SCHEDULE OF <u>AMENDMENTS</u>

S4.55 APPLICATION

ELEVATIONS:

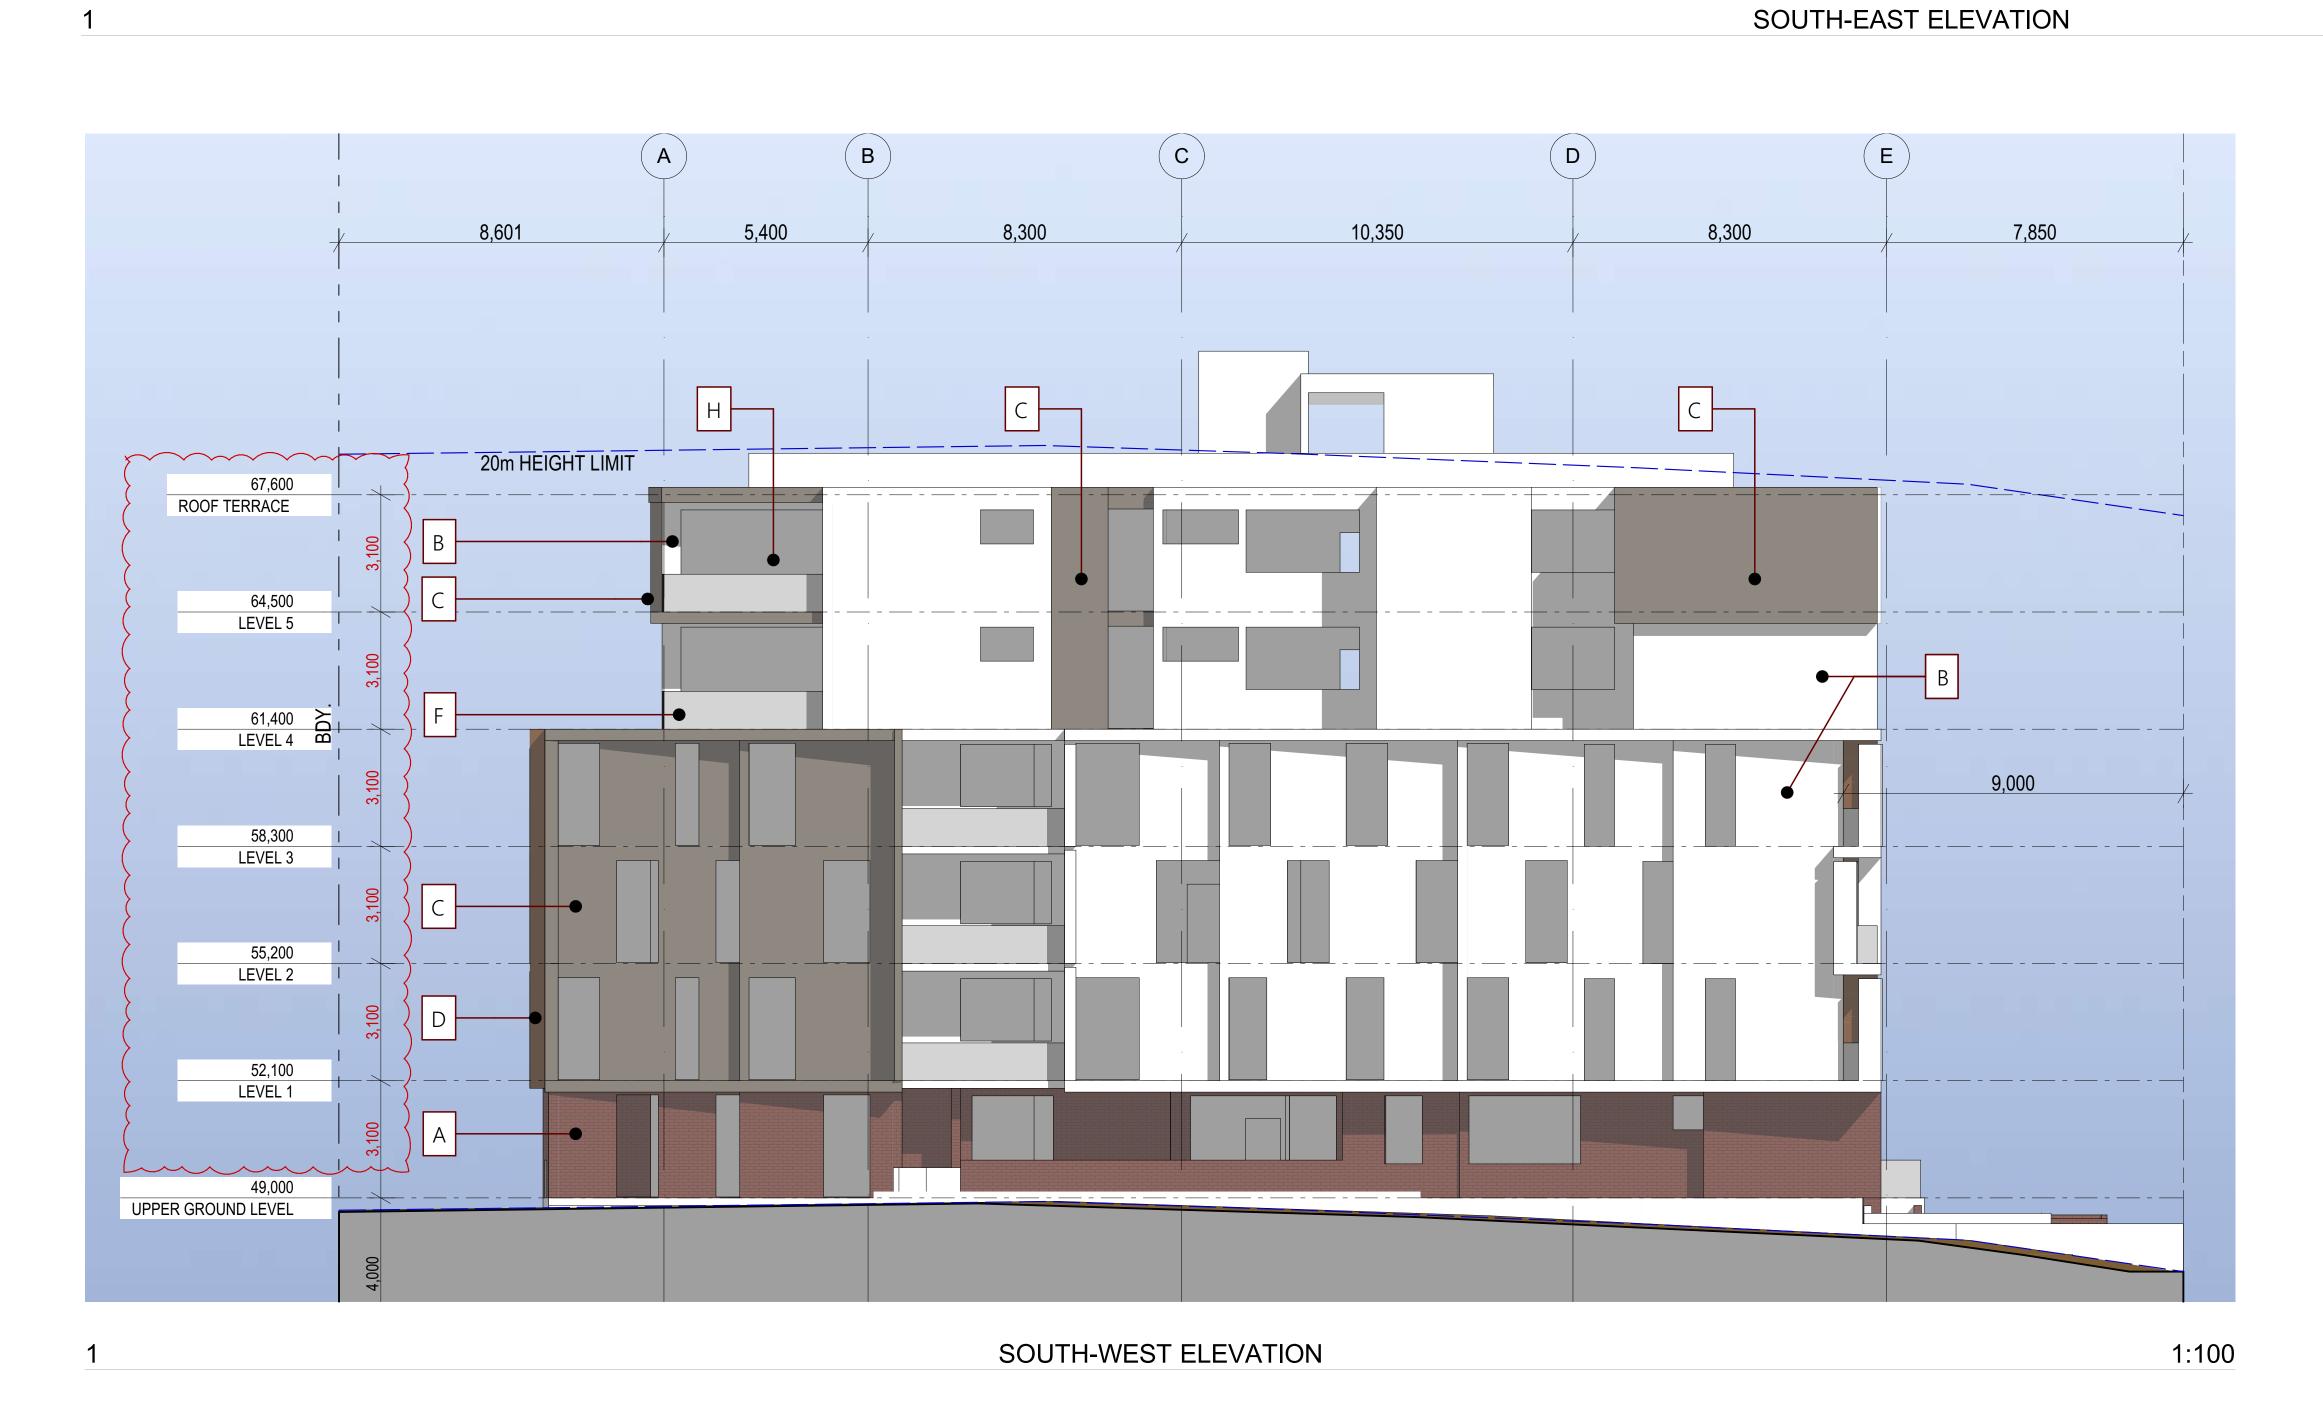
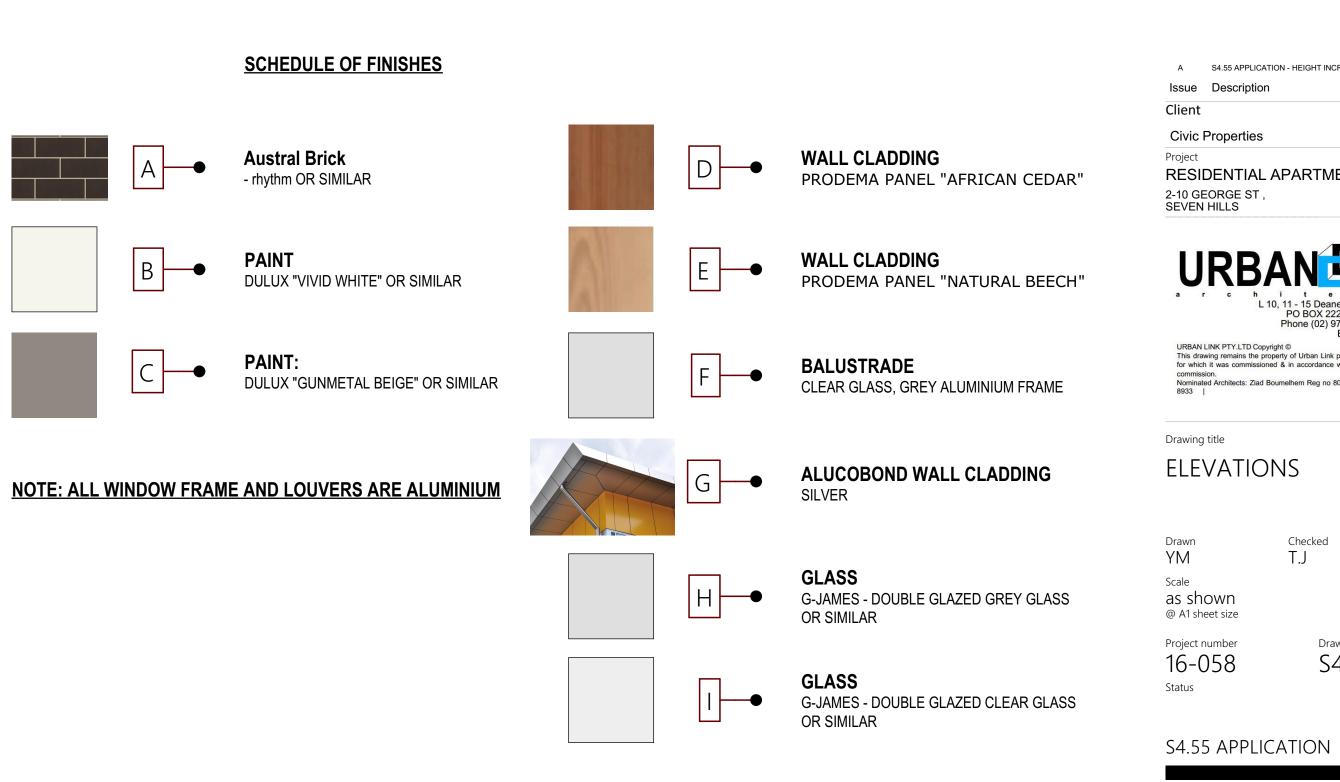
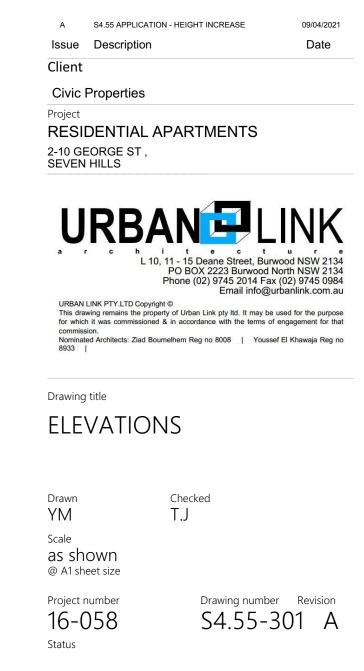
- 100mm increase in height on the residential levels from 3m (floor to floor) to 3.1m (floor to floor)
- overall height increase to the building by 600mm.

ELEVATIONS:

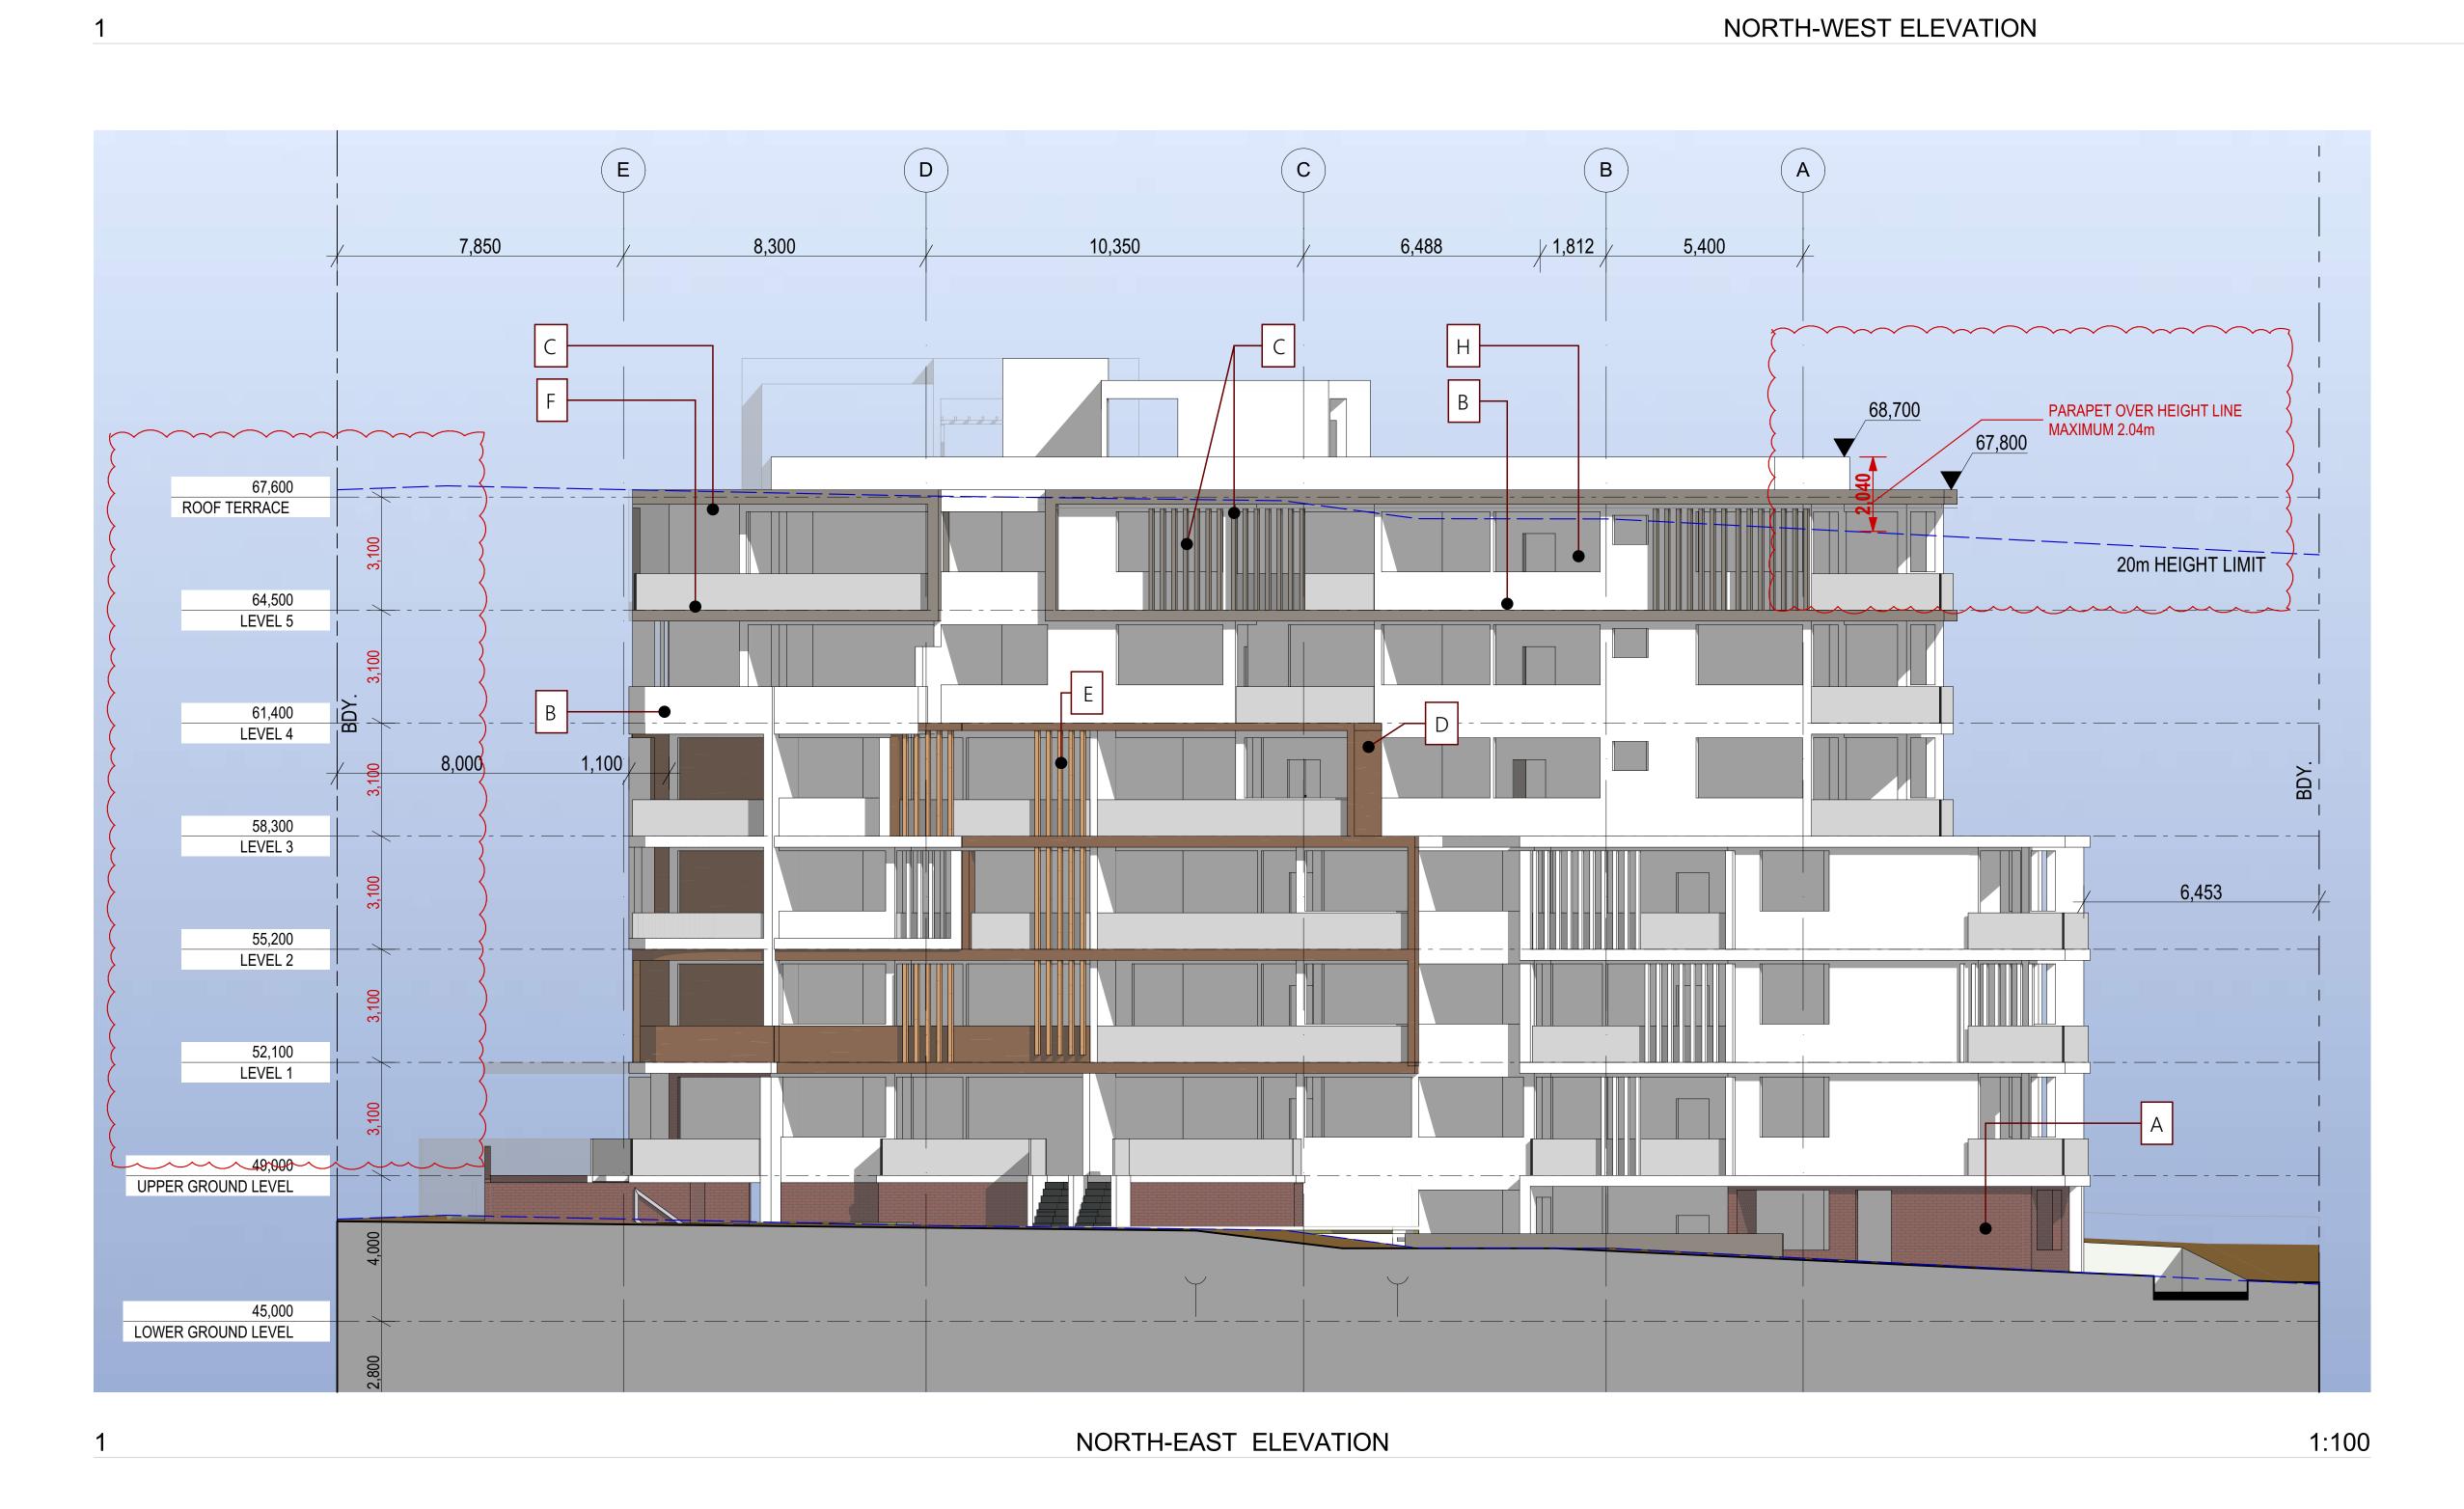
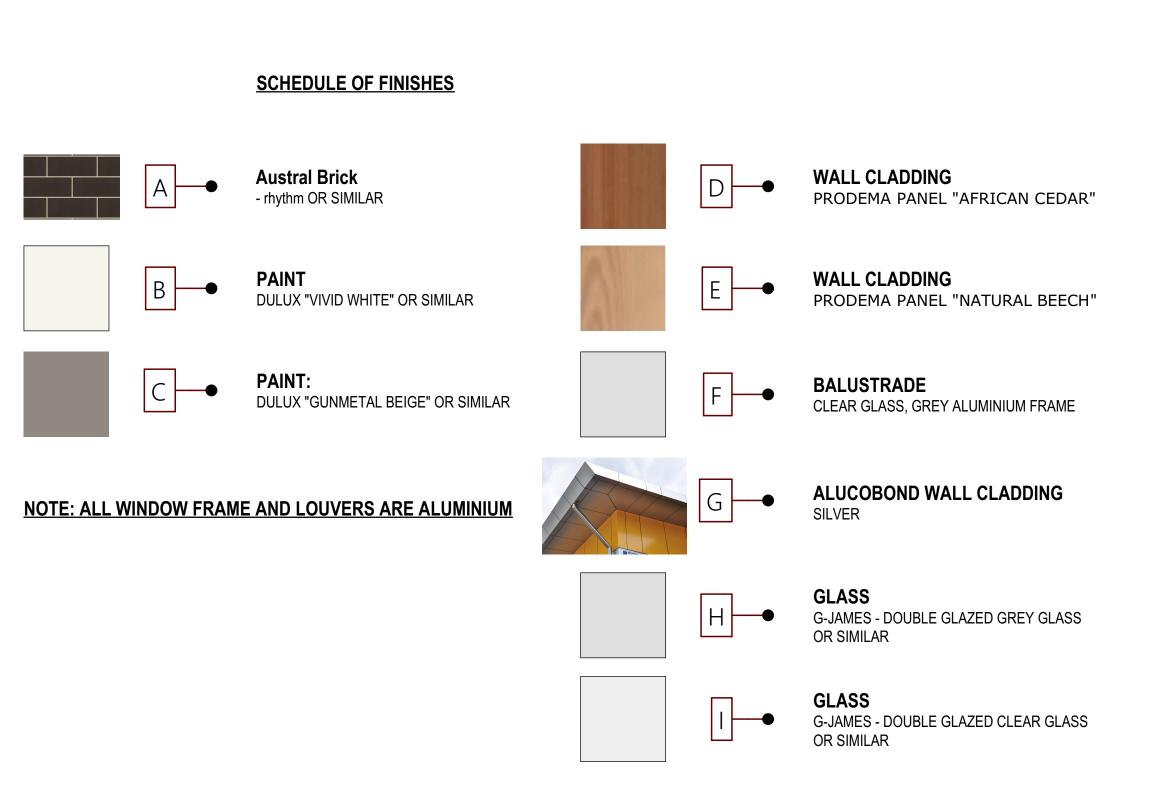
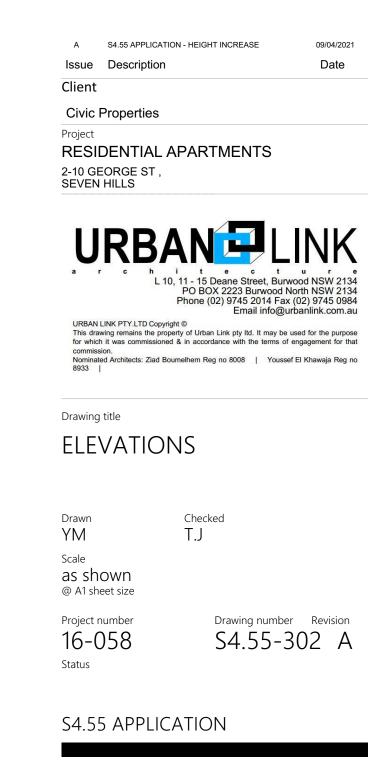
- 100mm increase in height on the residential levels from 3m (floor to floor) to 3.1m (floor to floor)
- overall height increase to the building by 600mm
